ENGINEERING CHANGE NOTICE1. ECN **604152**Page 1 of 2Proj.
ECN

5. Project Title/No./Work Order No. Hanford Patrol Academy Demolition Sites Sampling and Analysis Plan	6. Bldg./Sys./Fac. No. N/A	7. Approval Designator N/A JB

8. Document Numbers Changed by this ECN (includes sheet no. and rev.) WHC-SD-EN-TI-284, Rev 0, Page 4	9. Related ECN No(s). N/A	10. Related PO No. N/A
11a. Modification Work <input type="checkbox"/> Yes (fill out Blk. 11b) <input checked="" type="checkbox"/> No (NA Blks. 11b, 11c, 11d)	11b. Work Package No. N/A	11c. Modification Work Complete R. K. Bhatia <i>R. K. Bhatia 11/30/94</i> Cog. Engineer Signature & Date	11d. Restored to Original Condition (Temp. or Standby ECN only) F. A. Ruck <i>R. K. Bhatia 11/30/94</i> Cog. Engineer Signature & Date

Figure 3. Soil Sampling Locations/Depth Closure Area No. 2.

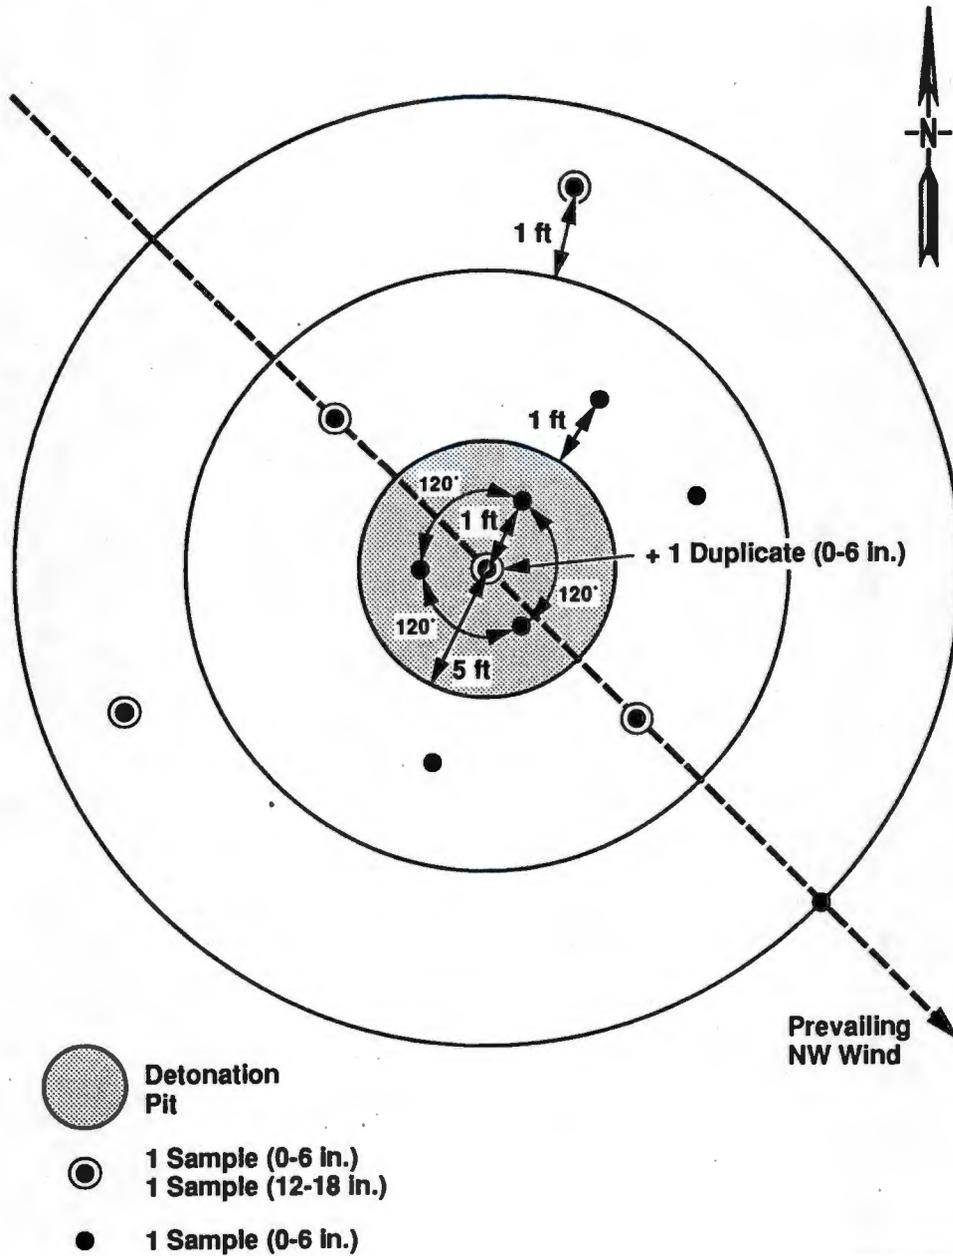
12. Description of Change
 Figure 3 incorrectly shows the radius of the detonation to be 2 ft. Figure 3 will be revised to show the radius of the detonation pit to be 5 ft.

13b. Justification Details
 Change the radius of the detonation pit to 5 ft.
